Wahroonga Estate Concept Plan

*Part 3A Section 75W
Modification Assessment
(MP07_0166 MOD 8)*

September 2019

Figure 9 | RTS plans showing specific floor levels and location of plant and roof terraces (Base source: RtS)

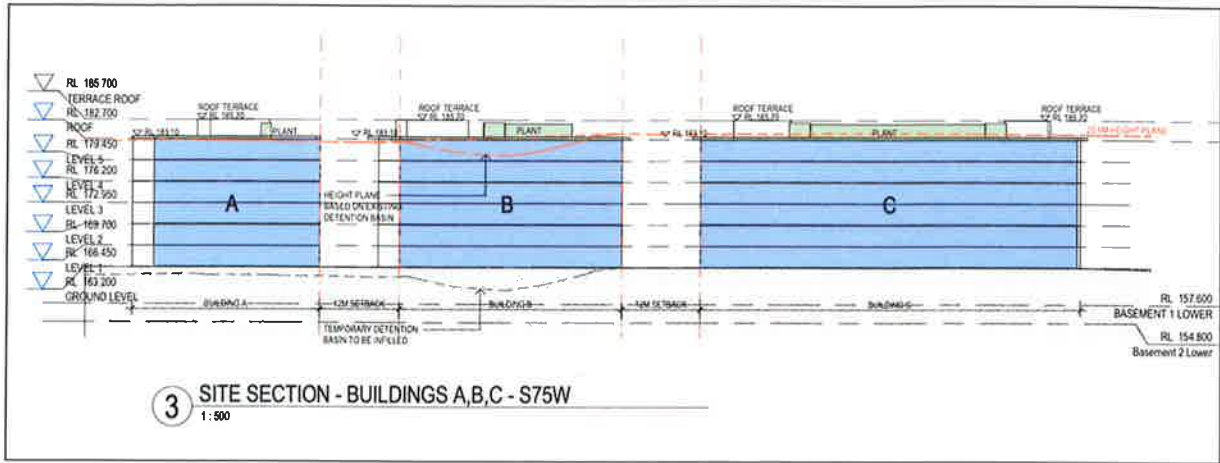
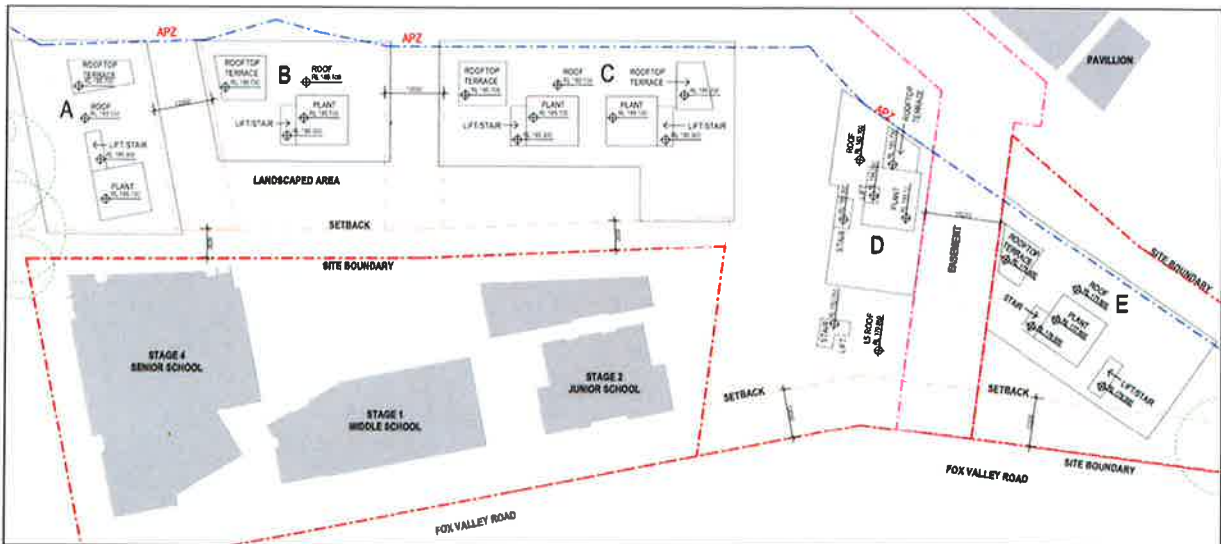
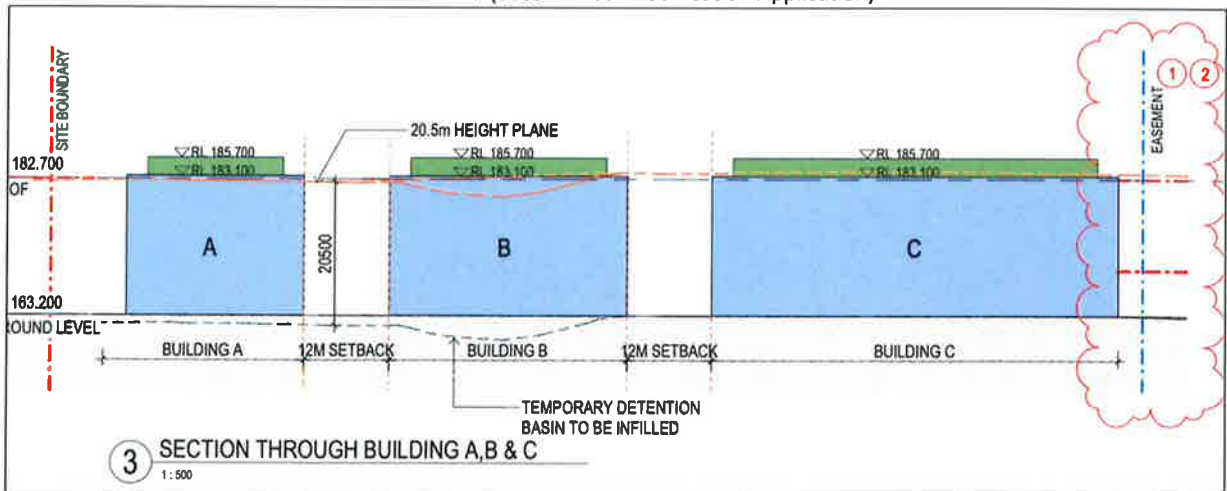
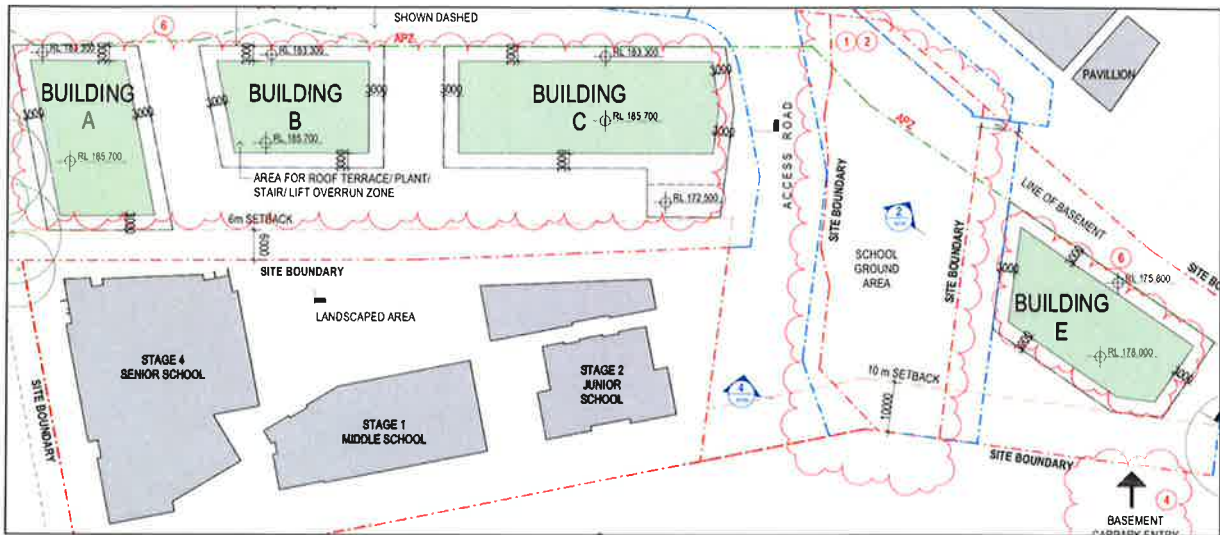
Council and public submission raised concern about the level of detail provided in the proposed plans, which would significantly affect the future built form on the site.

The modification and RTS initially proposed detailed plans which established the internal floor levels for each building (**Figure 9**) and set specific locations for the provision of rooftop plant, terraces and lift overruns (**Figure 10**). The submitted plans also included indicative internal floorplan layouts for each building.

Concern was raised about the proposed plans being too detailed for a Concept Plan approval and would effectively lock in the future design of buildings, circumventing Council's authority to require material amendments at the DA stage to address amenity, design and environmental impact issues which have not been assessed in detail as part of the Concept Plan approval. Council also advised that the detailed plans would also have the effect of overriding a number of existing controls which would otherwise apply to the assessment of future DAs, including the size of the top floor and modulation to massing to minimise apparent building length.

In response, the Proponent amended the building envelope plans in the SRtS to remove internal floor levels and allow for the provision of roof level plant and services within any part the roof, subject to a setback of three metres from the building line, as can be seen in **Figures 11 and 12**.

Council subsequently advised that the amended building envelopes has addressed its earlier concerns in terms of the level of detail required at the Concept Plan stage. It recommended that a condition be included to ensure the top level is limited to plant and roof top terraces only, as per the proposed plans.

The Department considers the level of detail in the revised building envelope plans is appropriate for a Concept Plan. The envelopes will still allow Council to require further modulation, articulation and detailed design of the buildings. To ensure there is no ambiguity in future DAs, a FAR has been recommended specifying that the top level is not to include residential floor space and is limited to plant and roof top terraces only.

Figure 13 | 3D view of proposed building envelope controls compared to existing LEP 20.5m and 14.5m controls (Base source: SRTs)

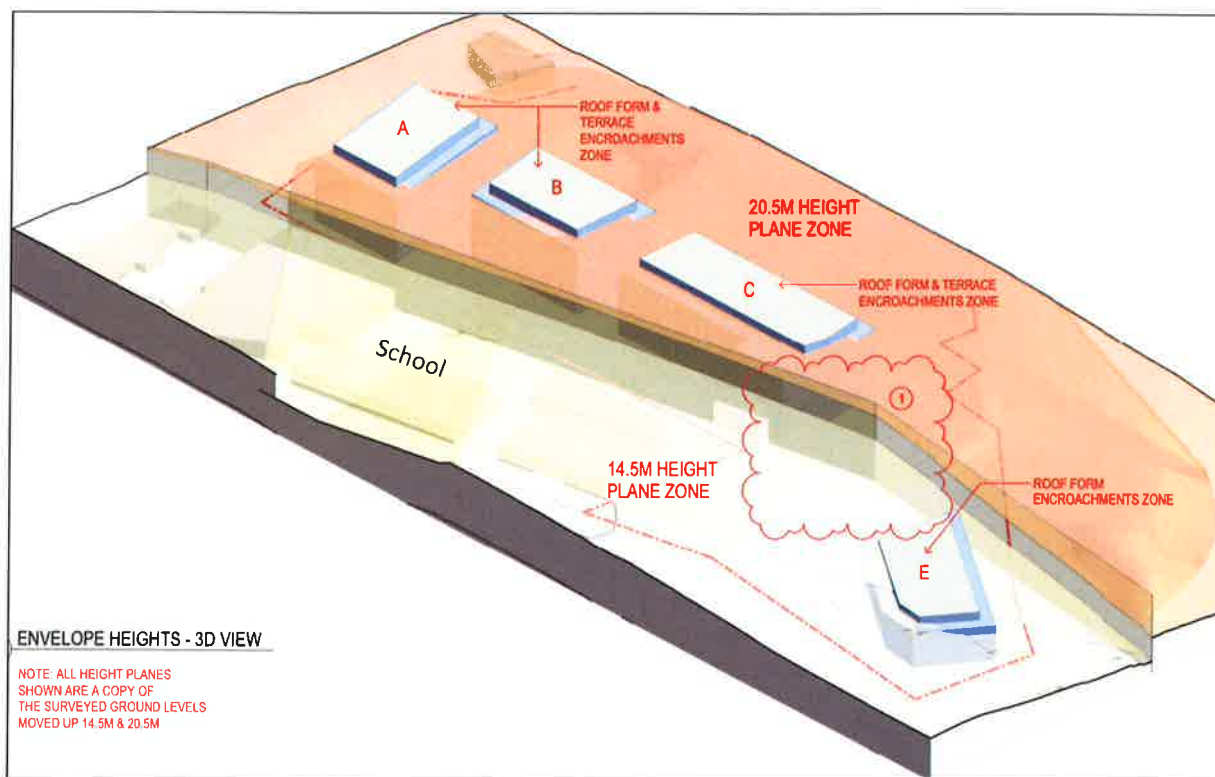
with the controls. Other than a negligible encroachment at the top of the front façade of Building B, the encroachments of the LEP height controls would be limited to the rear of the buildings and the rooftop plant which would be setback from the building edge (as seen in **Figure 13**). The Department is therefore satisfied these encroachments are relatively minor and would not result in any significant increase in overshadowing or overlooking impacts upon the school.

The Department is also satisfied the proposal would not result in any adverse visual impacts as the building envelopes would be consistent with the height controls when viewed from the school and Fox Valley Road.

While the proposed building envelopes would present one storey higher than currently permitted by the controls from the rear of the site, the Department is satisfied that no significant visual impacts would arise given the height increase is minor and the site predominantly backs onto bushland with limited viewing opportunities. The Department also notes that through careful design at the DA stage, future buildings can be designed to ensure visual impacts, shadowing and overlooking are minimised where appropriate.

Figure 14 | Proposed building footprints compared to approved footprints (Base source: SRTS)

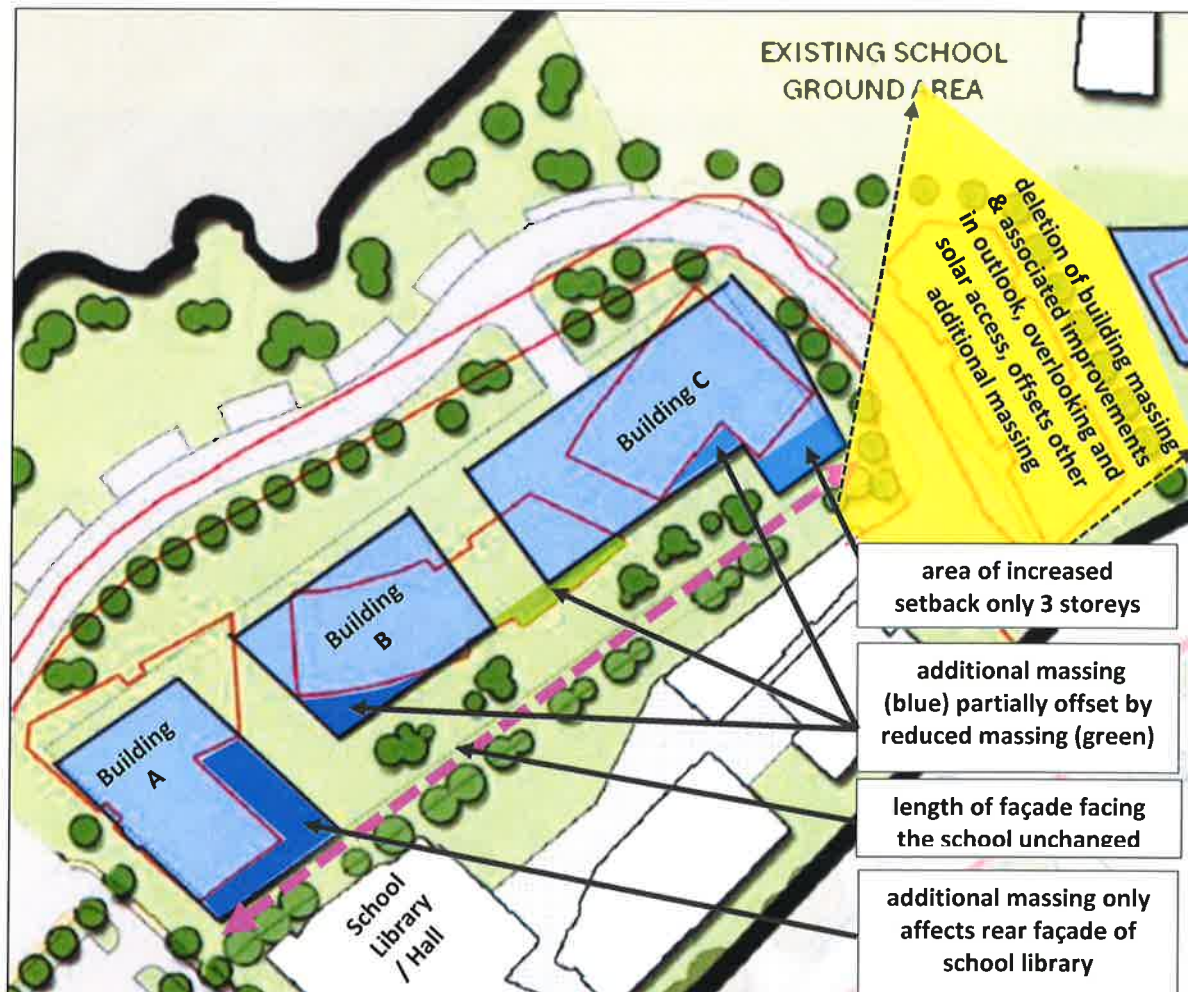
Council and public submissions raised the following concerns with respect to the building massing proposed by the modification application and RtS:

The most noticeable change to the building massing when viewed from the school site is at Building A, shown above in **Figure 14**. However, the Department considers the proposed changes are acceptable as the additional massing in this location only affects the north-western façade of the future school hall / library building, rather than the main open space or circulation area of the school.

- deletion of Building D, which will open up view corridors, visual and physical links between the school and the playing fields, and reduce overshadowing and overlooking from the north-east (as illustrated in **Figure 14**)
- stepping down the proposed height of the south-west wing of Building C so that it would be only 3 storeys tall close to the school
- removing most of the details from the submitted plans, which will enable future DAs to incorporate modulation and massing to address amenity impacts and Council's controls.

The Department considers that the proposed modifications to the building envelopes, footprints and setbacks would result in an overall net improvement to the amenity of the school, noting that:

- the overall length of the façades of Buildings A, B and C facing towards the school remains the same
- the deletion of Building D results in significant improvements in terms of outlook and solar access to the north-east which offsets the impacts of other areas of increased massing
- the area of Building C closest to the school would be 3 storeys in scale to minimise impacts
- other areas of increased massing on the façades of Buildings B and C are at least partially offset by reduced massing elsewhere on the façades
- a minimum boundary setback of 6 metres is retained, which is sufficient to provide a dense landscaped setback to partially screen and reduce visual impacts to the school.

The Department is satisfied the Proponent has appropriately located the building footprints to minimise impacts to the school as much as possible. Overall, the Department considers the amenity of the school would be improved by the modification, particularly given the benefits arising from the deletion of Building D.

Figure 16 | Extract from original approval documents showing APZ lines. APZs are measured from a line of undisturbed vegetation which was adopted as the E2 Conservation Zone Boundary line (Base source: Final Preferred Project Report)

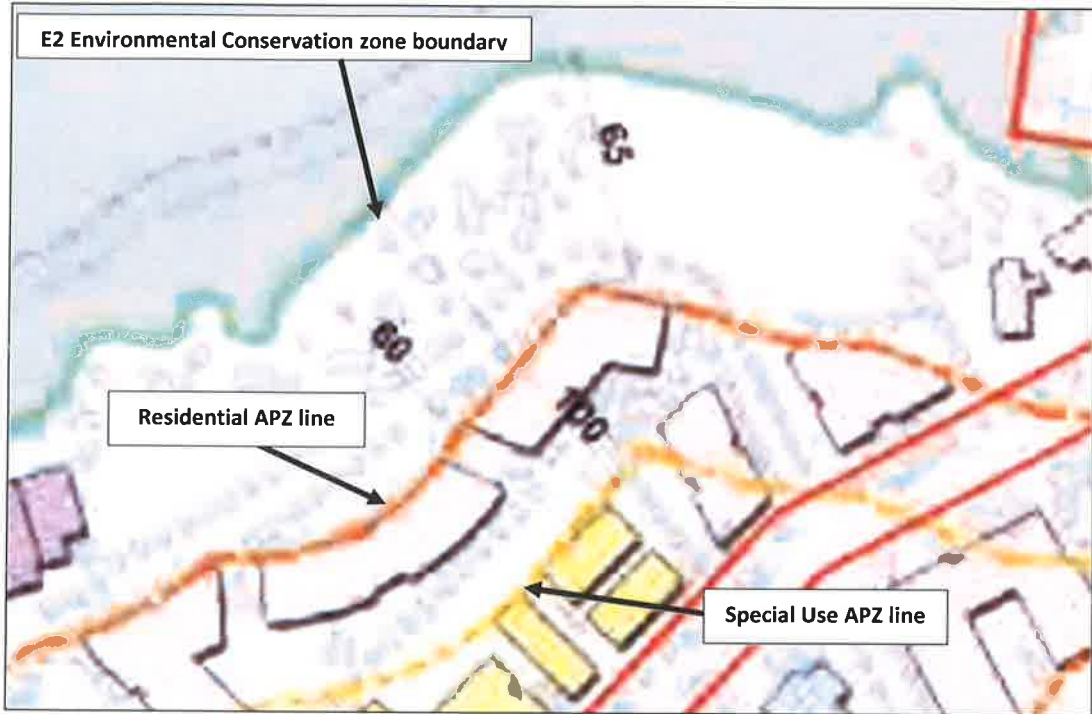
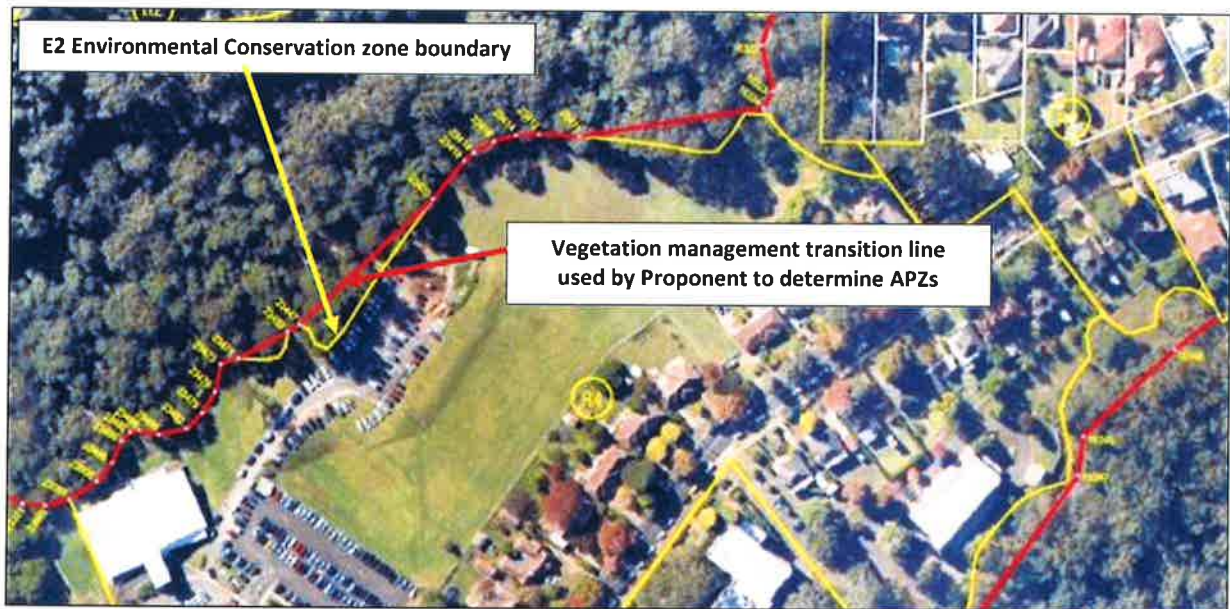
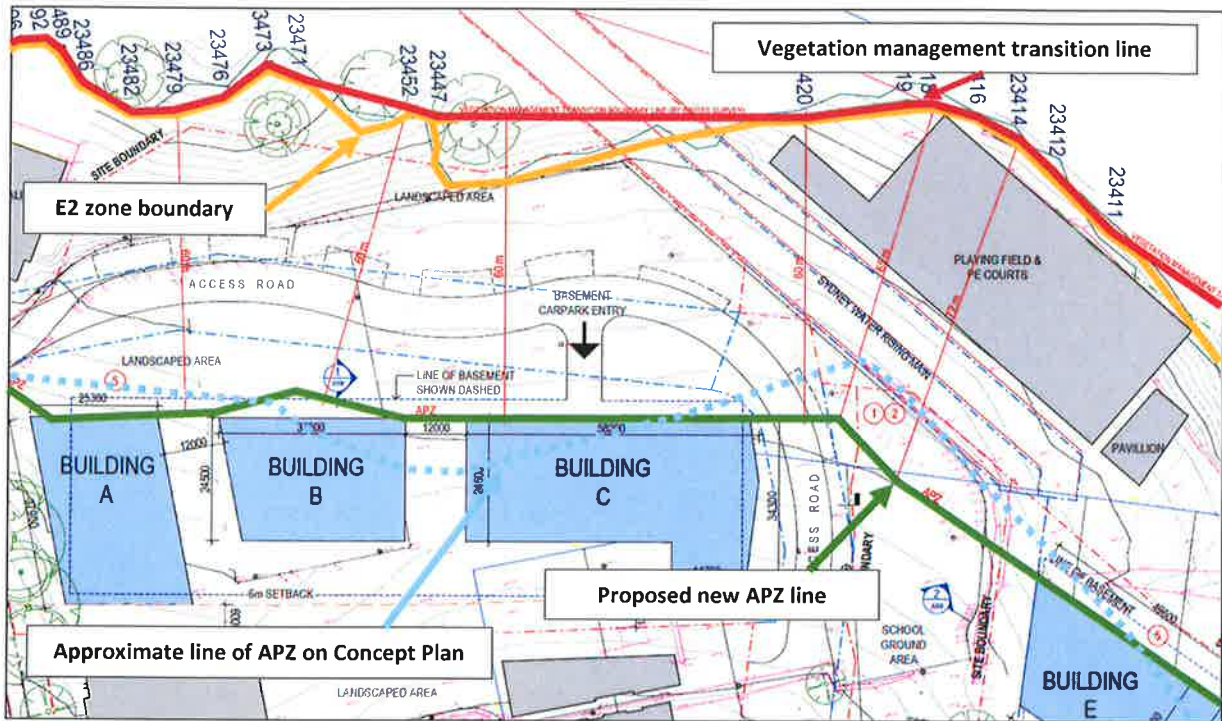
Council and public submissions raised concern about the revised building envelopes encroaching into the bushfire asset protection zones (APZs) shown on the plans. Council also advised that the placement of the buildings, internal roadway configuration and water supply should be considered in terms of bushfire safety. In response, the Proponent amended the plans so that the envelopes aligned with the APZ identified on the plans. Council reviewed the plans and reiterated that the plans must ensure no part of any building footprint encroaches into the APZ.

The Department is satisfied the revised plans comply with the APZs shown on the modification plans but notes that the APZ lines shown on the plans are inconsistent with the APZs required under the original Concept Approval.

Under the original approval, an APZ of 60 m (Buildings A B and C) and 65m (Building E) was established. During the assessment of the original application, and in response to concerns regarding biodiversity impacts, the APZ was specifically amended so that it did not encroach into the E2 Environmental Conservation zone. FAR B5(1) was also included in the approval as follows:

The Proponent has advised that the APZs shown on the modification plans is not based strictly on the E2 Environmental Conservation zone boundary, but rather, another line located partially within the E2 Conservation zone. The difference between the APZ shown on the approved Concept Plan and the APZ shown on the modification plans is shown in **Figures 16 to 18**.

However, the Department notes that the revision to the APZs has never been specifically sought as a modification to the Concept Plan. The Department considers the APZ shown on the modification plans would be inconsistent with the intention of the original approval, as it would potentially require removal of vegetation within the conservation land and / or could prevent rehabilitation and revegetation of this area with associated potential biodiversity impacts, contrary to the intention of the zone and FAR B5 (1). The Department therefore maintains its original position that no part of the conservation zone should form part of the APZ. FAR B5(1) is recommended to be retained and a further FAR is recommended requiring that building footprints be adjusted, if necessary, to comply with the APZ requirements.

In this regard, the Department also notes that the 2018 version of Planning for Bushfire Protection is due to supersede the 2006 requirements this year and is currently able to be used in performance solutions. The Proponent has advised that it is likely that a revised assessment of APZ requirements under the updated version of Planning for Bushfire Protection may result in a slightly reduced width of the required APZ. This may enable the building footprints as shown on the plans to be largely retained as proposed, whilst still ensuring the APZ does not encroach into the conservation zone. The Department therefore recommends FAR B5 be updated to require that future applications comply with the requirements of Planning for Bushfire Protection applicable at the time of the assessment of future DAs. This is consistent with the advice from RFS that future development should comply with Planning for Bush Fire Protection 2018 and subsequent versions.
